May 8, 2024

Re: Easton Manor Preliminary Drainage Report
Parcel #042026-7-027, 7-003, 7-028, 7-008, 7-007, & 7-001

DRAWING
D-1
SHEET
OF 1

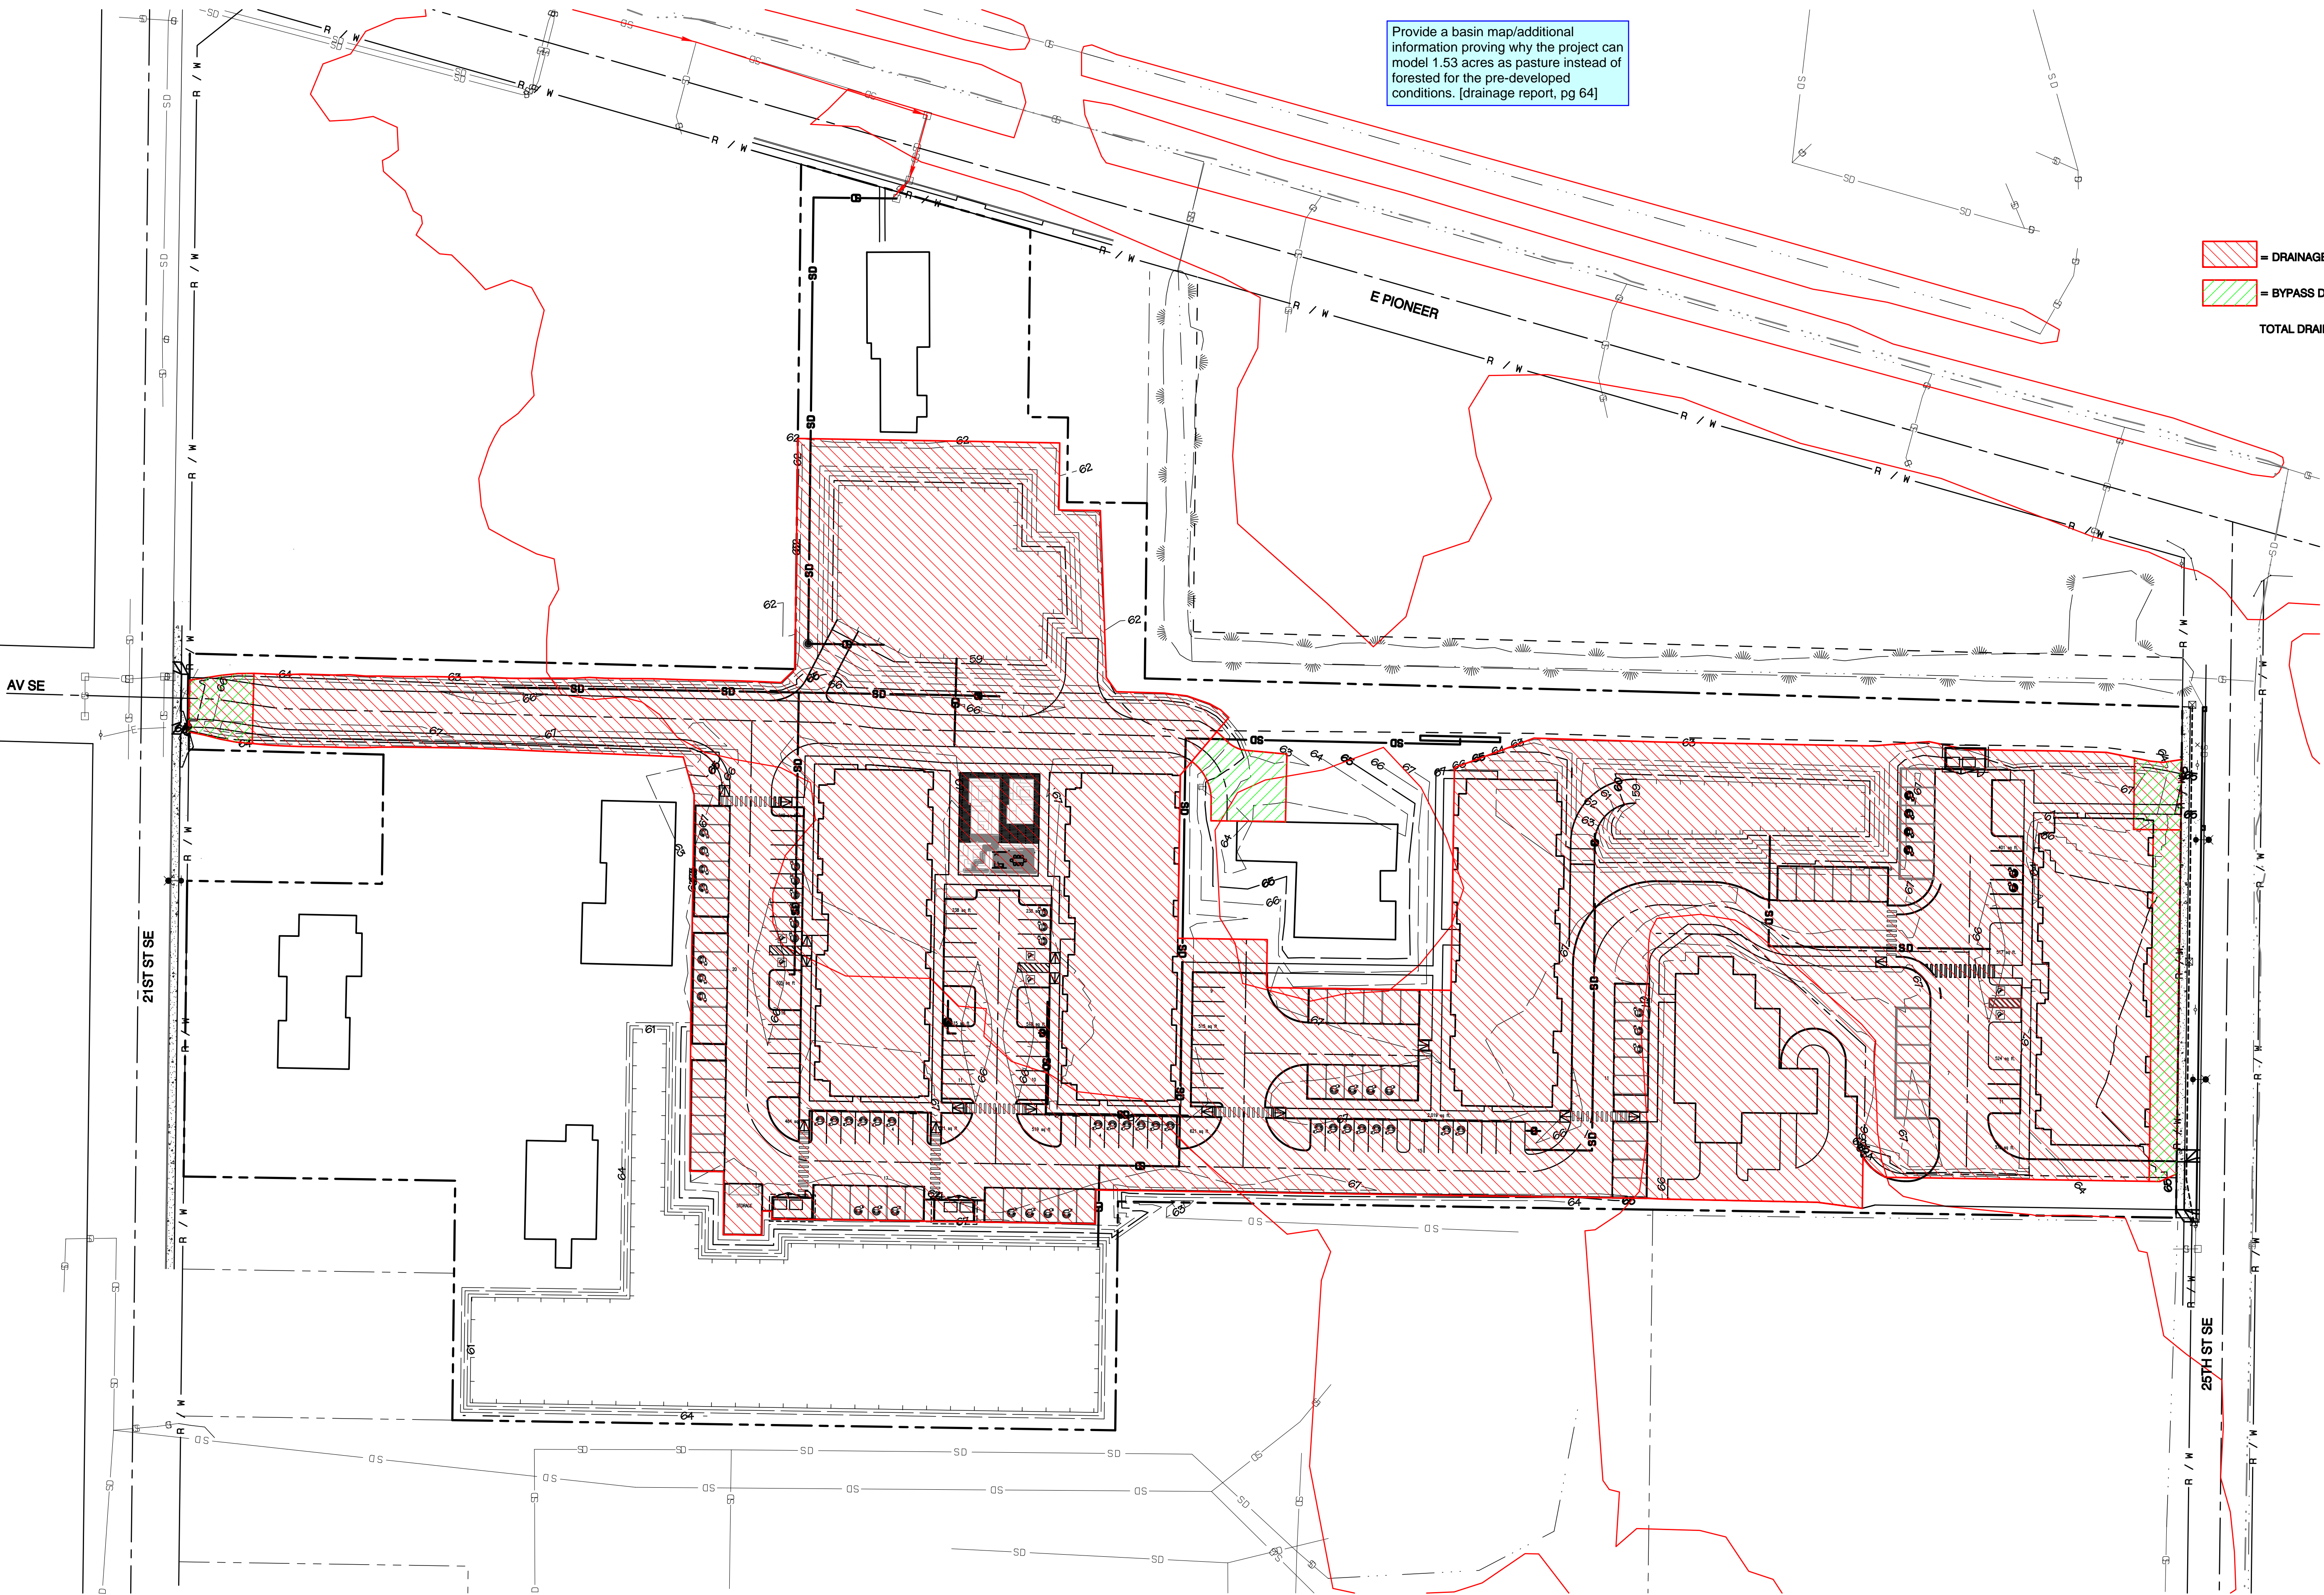
Provide a basin map/additional information proving why the project can model 1.53 acres as pasture instead of forested for the pre-developed conditions. [drainage report, pg 64]
